# MEMO

This memorandum has been prepared in response to the request for staff memorandum dated January 24, 2012 in the matter of applications for transfer/new water rights No. 73811, 73834, 63-32499, 61-12095, 61-12096, 63-32703, 61-12256, and 63-33344. The following information was requested:

RE: *Response to IDWR Staff Memo regarding the sufficiency of water supply for water right applications and transfers along the I-84 corridor*

## Rebuttal Report of Christian R. Petrich

Figure 2. Consolidated hearing study area boundary.

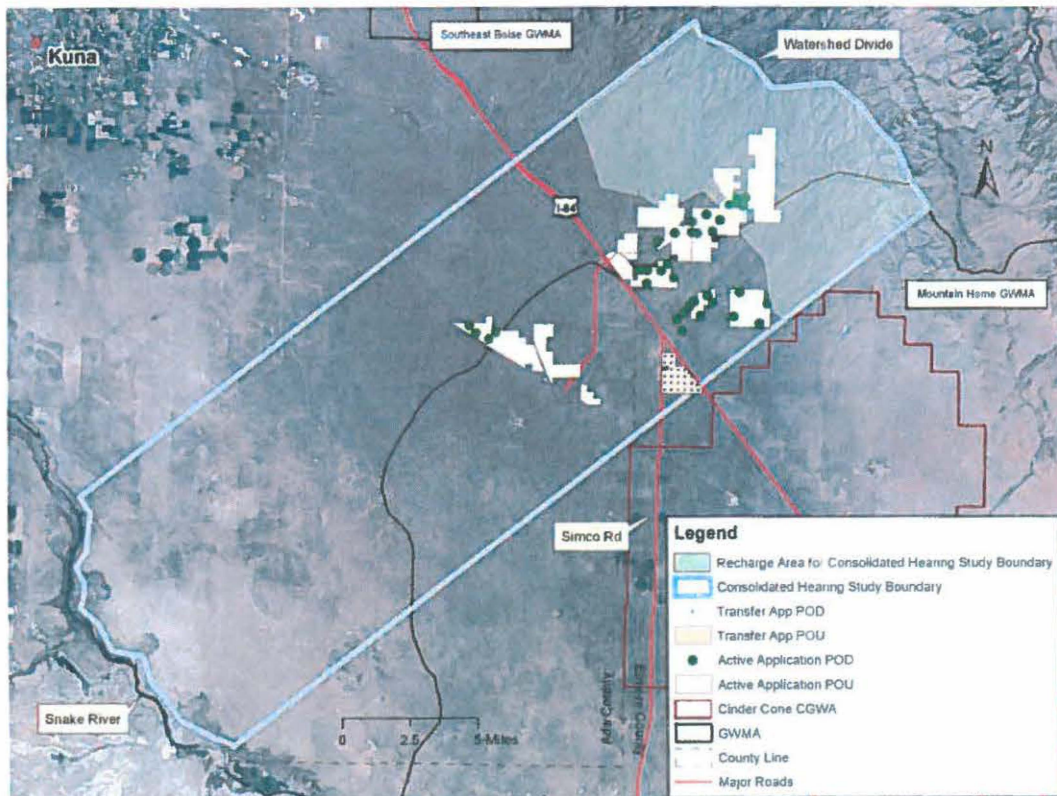
1. Contrary to ERO's assertions, the study area defined for this matter by the Idaho Department of Water Resources (IDWR) is appropriately sized and technically defensible. Constraining study-area dimensions to hydrogeologic features such as faults or geologic contacts (as ERO suggests) would require extending the study area to include the entire western Snake River Plain, an unwieldy and impractical study area for answering the specific water-budget questions at hand.

Response. The study area designated by IDWR for evaluating groundwater supply is appropriately sized and technically defensible. The study area encompasses all of the proposed points of diversion and proposed places of use. The study area is defined by defensible boundaries.

Figure 4. Water table contour map for October, 2011.

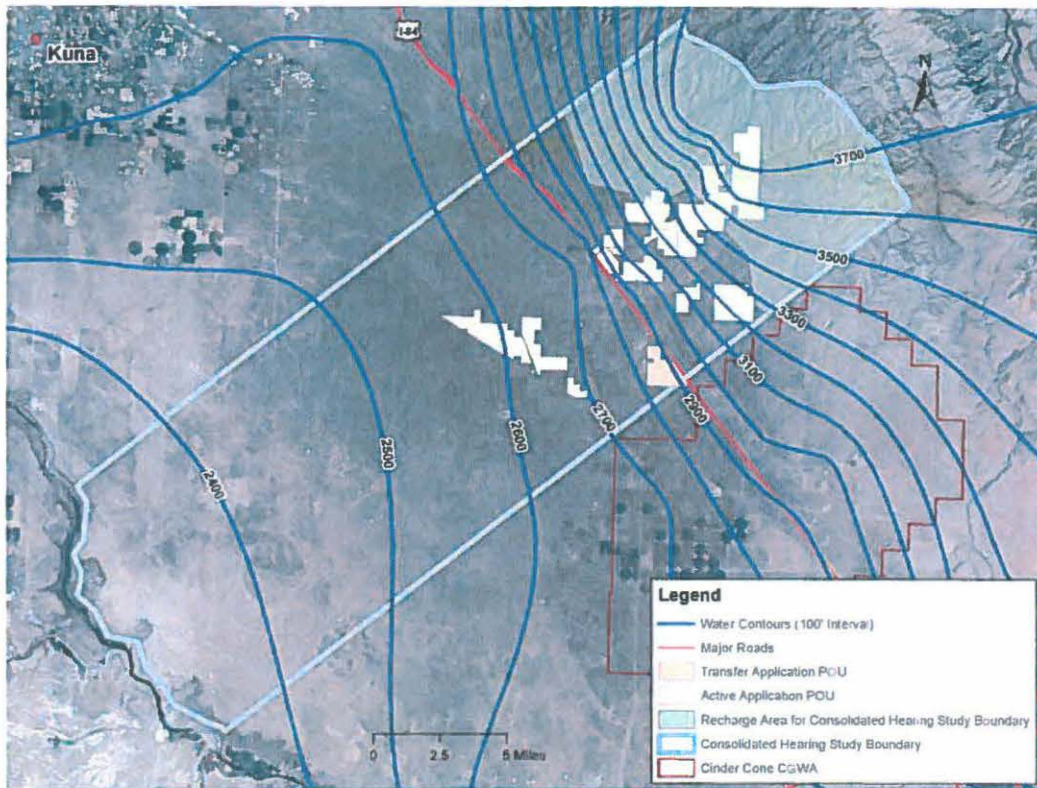
That said, the southwest-northeast study-area boundaries are not entirely perpendicular to IDWR's groundwater-level contours (see Figure 4 of the IDWR Staff Memo) in the southern portion of the study area. As such, the study boundaries appear to not be aligned along regional flow lines in this area. However, Lindholm et al. (1988) defined regional groundwater-level contours using a much larger (and more regional) data set. Figure 1 shows (a) Lindholm et al.'s groundwater-level contours, (b) IDWR groundwater-level contours presented in Figure 4 of the IDWR Staff Memo, and (c) IDWR water-level contours that SPF reinterpreted based on the previous Lindholm et al. contours. Inferred groundwater flow lines based on the IDWR contours and Lindholm et al. regional groundwater-level contours represent a reasonable basis for IDWR's southwest-northeast study-area boundaries.

Figure 5. Groundwater level change maps for the Cinder Cone CGWA for the fall season between the years (a) 1981 and 1991, (b) 1991 and 2001, (c) 2001 and 2011, and (d) 1981 and 2011.

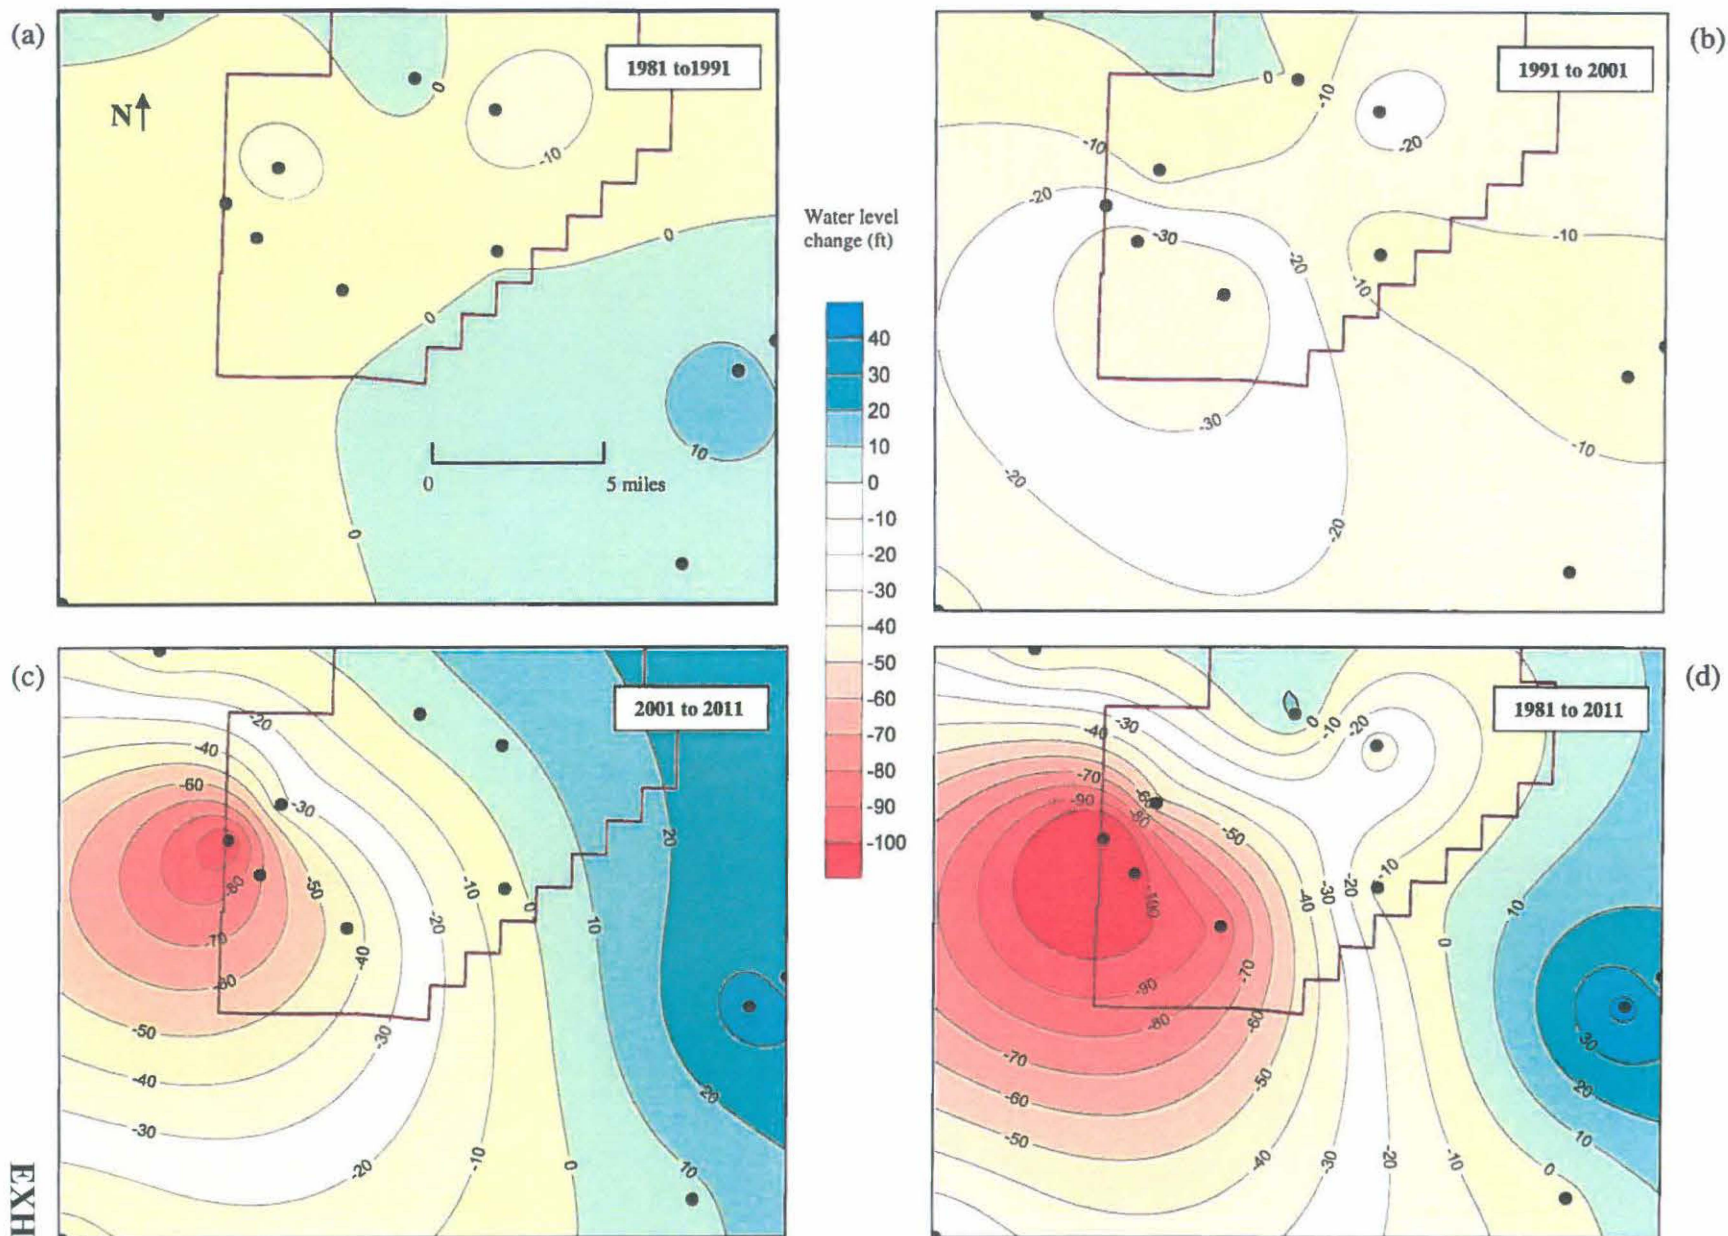
4. There clearly have been groundwater-level declines within the Cinder Cone Butte CGWA, but the degree to which water level declines within the CGWA have extended outside of the CGWA is unclear. Groundwater-level contours shown Figure 5 of the IDWR Staff Memo<sup>8</sup> show substantial declines extending west and southwest (i.e., outside) of the CGWA in the consolidated cases study area, but these depictions of the study-area groundwater-level declines represent a software interpolation unsupported by actual groundwater-level data.

3. ERO uses Figure 5 of the IDWR Staff Memo to suggest that a 20-mile diameter area of groundwater-level decline stemming from pumping in the Cinder Cone Butte Critical Ground Water Area (CGWA) extends substantially into the consolidated cases study area. However, the IDWR depictions of groundwater-level declines outside of the CGWA are based on software interpolation unsupported by actual groundwater-level data.

3. *ERO argues that "The diameter of the water level decline attributed to pumping in the CCBCGWA is approaching 20 miles" based on Figure 5 in the IDWR Staff Memo (ERO review, page 15), implying that pumping from the Cinder Cone Butte CGWA has materially impacted groundwater levels in the study area, rendering the boundary separating the study area and the comparison area invalid.*

ERO's argument appears to be based on a map of purported groundwater-level declines stemming from Cinder Cone Butte CGWA pumping (see Figure 5, IDWR Staff Memo). However, the IDWR depictions of groundwater-level declines outside of the CGWA are based on software interpolation unsupported by actual groundwater-level data. Furthermore, Figure 4 of the IDWR Staff Memo also does not appear to indicate groundwater-level declines within the study area stemming from Cinder Cone Butte CGWA pumping. Thus, neither Figures 4 nor 5 of the IDWR Staff Memo support the concept of a 20-mile diameter water-level decline attributable to pumping in the Cinder Cone Butte CGWA.

Perhaps more telling is that approximately 40 years of pumping in the Cinder Cone Butte area has not resulted in the type of water-level decline projected by ERO's Theis results. IDWR Figure 5(d) suggests that there has been zero water-level decline since 1981 in the vicinity of the proposed applications and transfers as a result of Cinder Cone Butte area pumping over the past several decades. Thus, although ERO's Theis analysis might predict widespread water-level decline within the study area as a result of proposed pumping, monitoring data from actual pumping in the Cinder Cone Butte area demonstrate otherwise.

Figure 9. Comparison of Newton (1991) model zone locations interpreted by IDWR and SPF.

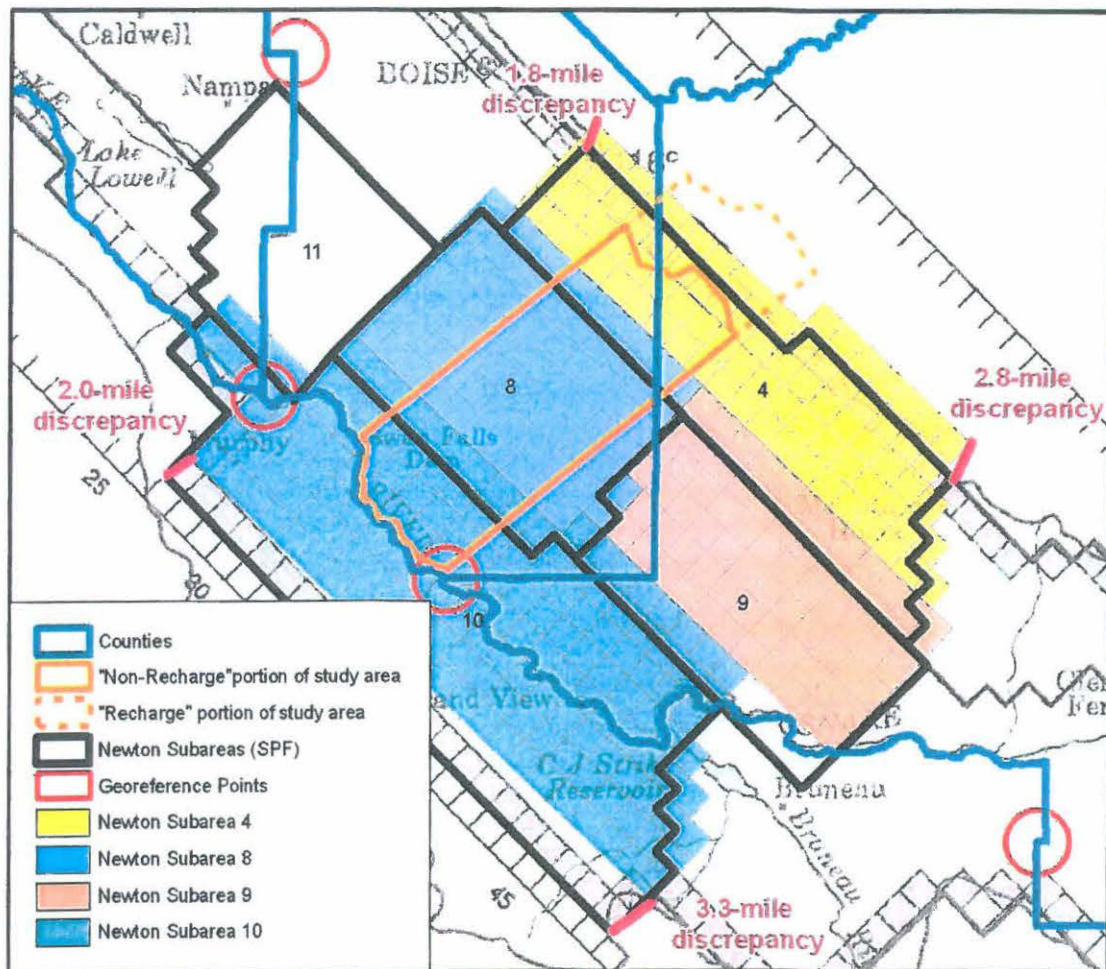
In calculating recharge for the "non-recharge" area using USGS subareas we found a discrepancy in IDWR's geo-referencing of the Newton (1991) subarea map. Correcting this discrepancy resulted in a recharge estimate of 3,000 AF for the "non-recharge" area, which is approximately 340 AF greater than the 2,660 AF recharge volume estimate presented in the IDWR Staff Memo (Table 2).

The geo-referencing discrepancy is illustrated in Figure 9. SPF scanned Figure 17 in the Newton (1991) report and geo-referenced this map using county shapefile polylines (6 points) as reference points. IDWR's geo-referencing was off by distances

of 1.8 to 3.3 miles at four representative corner points (Figure 9). Examples of SPF's geo-referencing points are shown in Figure 10. The net result is that there is a larger portion of USGS subarea 4 and a smaller portion of Subarea 10 in the consolidated cases study area than calculated by IDWR.

Recharge was recalculated using IDWR's PRISM dataset and the revised subarea acreages within the consolidated cases study area (PRISM raster data were converted to point shapefiles to simplify analysis in ArcGIS v9.2). Points lying within the boundaries of the "non-recharge" area and Newton subarea were selected and precipitation summed. Recharge was computed based on the recharge ratios

presented by Newton (1991, Table 6). This resulted in a recharge estimate for the “non-recharge” area that is 340 AF (13%) greater than that calculated by IDWR.
